Minerals and Waste Joint Plan

Sustainability Appraisal Addendum Proposed Changes to the Publication Draft

Sustainability Appraisal Report - Addendum of
Proposed Changes to Publication Draft Plan

June 2017

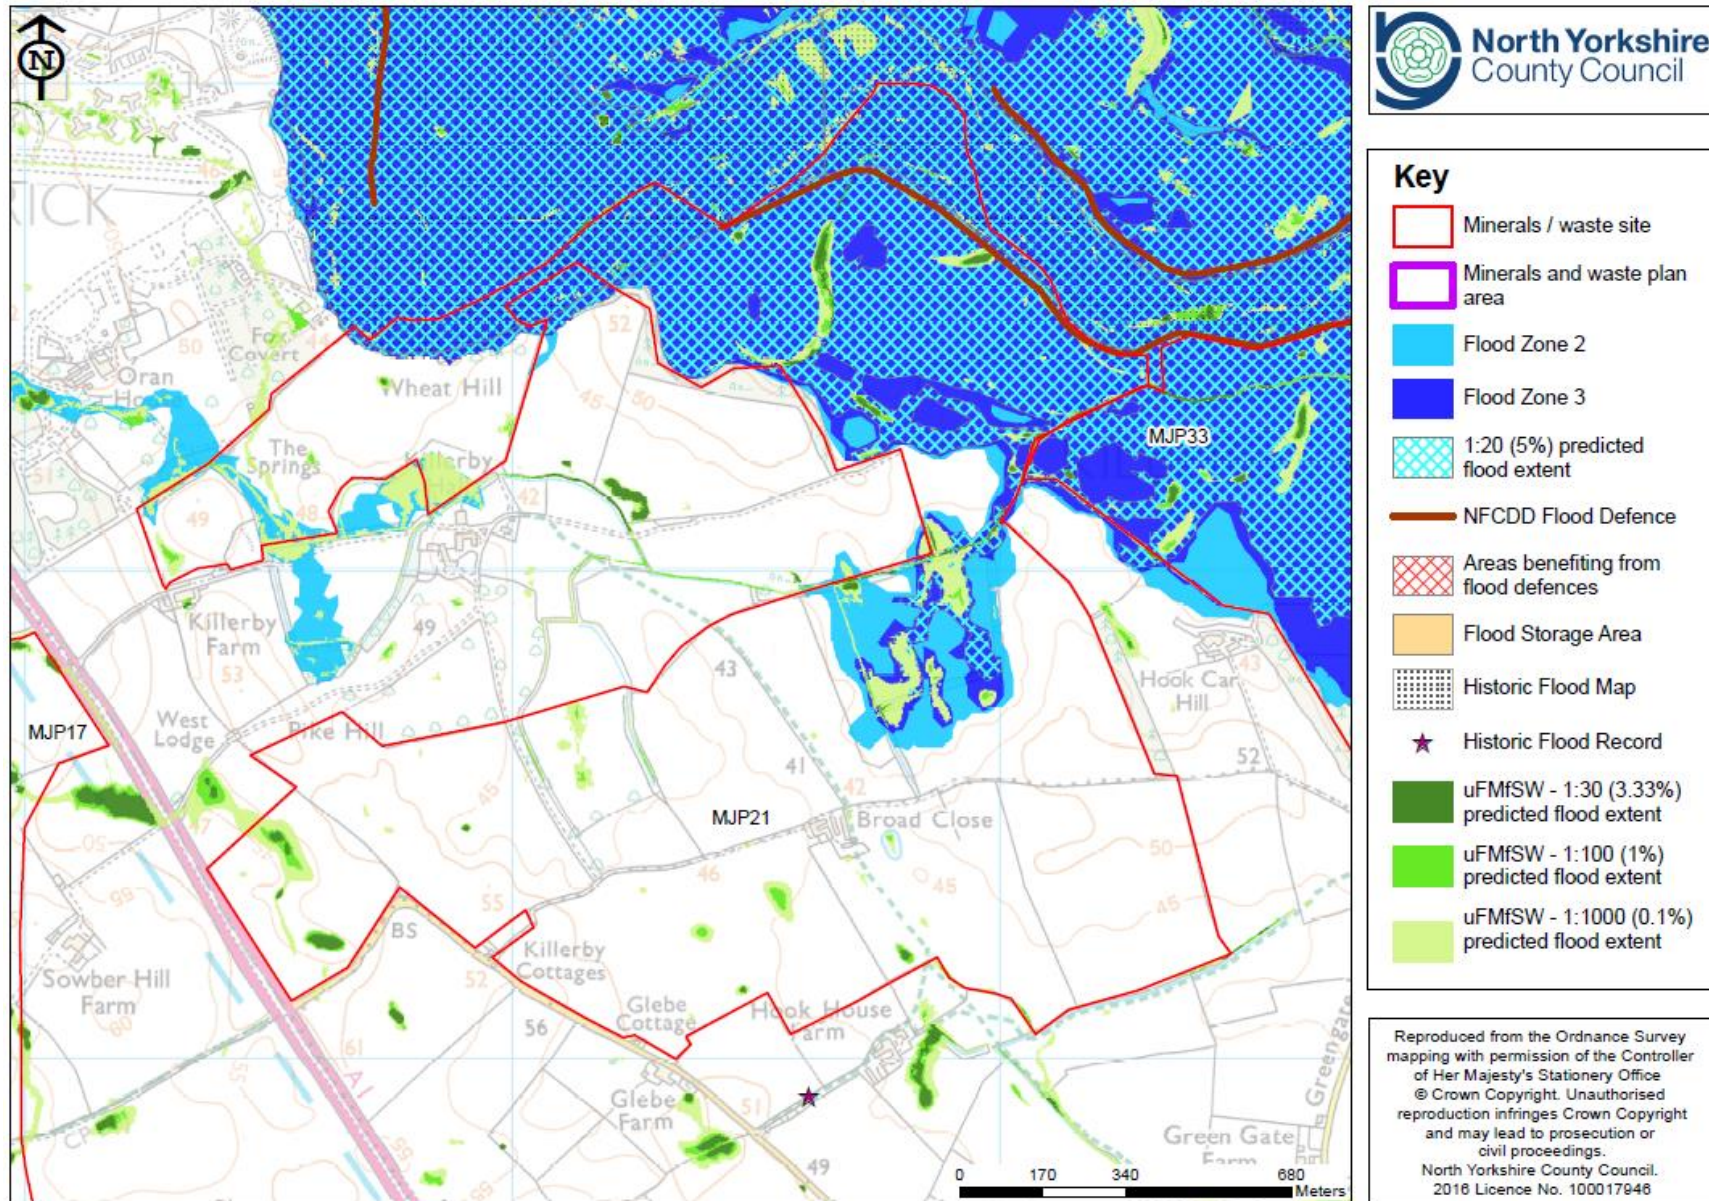
MJP21 Site Plan (PC102)	35	Revise site boundary of allocation MJP21 to exclude land nearest to the Killerby Hall Stable Block listed building. There would be a reduction in the overall area of the site from 213ha to 207ha, with a	To reduce the harm to the setting of the listed building	There would be a proportionate increase of the site area within flood zones 2 and 3 from approximately 35% to 40% of the site, due to the revised boundary resulting in a loss of area

Policy Ref/ Paragraph Number/ Reference point	Page Number	Change Proposed	Reason	Sustainability Appraisal Screening
		subsequent sand and gravel reserve reduction of 1 million tonnes.		<p>within flood zone 1. This area will increase in size due to the effects of climate change in the long term.</p> <p>Land removed from the site is ALC Grade 3 and therefore an additional 6ha agricultural land would be preserved from development, benefitting agricultural land lost to climate change in the long term.</p> <p>The above changes are not considered to result in a change to the SA score applied to SA Objective 7 (To respond and adapt to the effects of climate change).</p> <p>There would be a reduction in 1 million tonnes of virgin sand and gravel removed from the site due to the reduction in area of the site. Therefore preserved sand and gravel would be available for future use.</p> <p>This is not considered to result in a change to the SA score applied to SA Objective 8 (To minimise the use of resources and encourage their re-use and safeguarding).</p> <p>The revision of the site boundary to exclude</p>

Policy Ref/ Paragraph Number/ Reference point	Page Number	Change Proposed	Reason	Sustainability Appraisal Screening
				<p>land nearest to Killerby Hall Stable Block listed building would affect the SA Objective 10 score (historic environment).</p> <p>Change to SA Objective 10 score (historic environment). See Table 3.4 below for updated score and justification.</p> <p>The amount of sand and gravel extracted from the site would be reduced from 11.37 to 10.37 million tonnes. Reducing the sites contribution to the construction sector.</p> <p>Overall the change is considered negligible in relation to achieving SA Objective 12 (Achieve sustainable economic growth and create and support jobs), and therefore no change has been applied.</p> <p>There would be a proportionate increase of the site area within flood zones 2 and 3 from approximately 35% to 40% of the site, as a result of the loss of land outside of these zones. This is not considered to affect the SA score applied to SA objective 16 (flood risk). See updated SFRA in Appendix 2.</p>

- MJP21 SFRA – a decrease in area of 6ha has not resulted in a change to the sequential test result or ranking of the site.
- MJP21 HIA – the removal of the area of land south of the Killerby is expected to reduce the overall effect from minor negative to negligible following the proposed restoration measures.
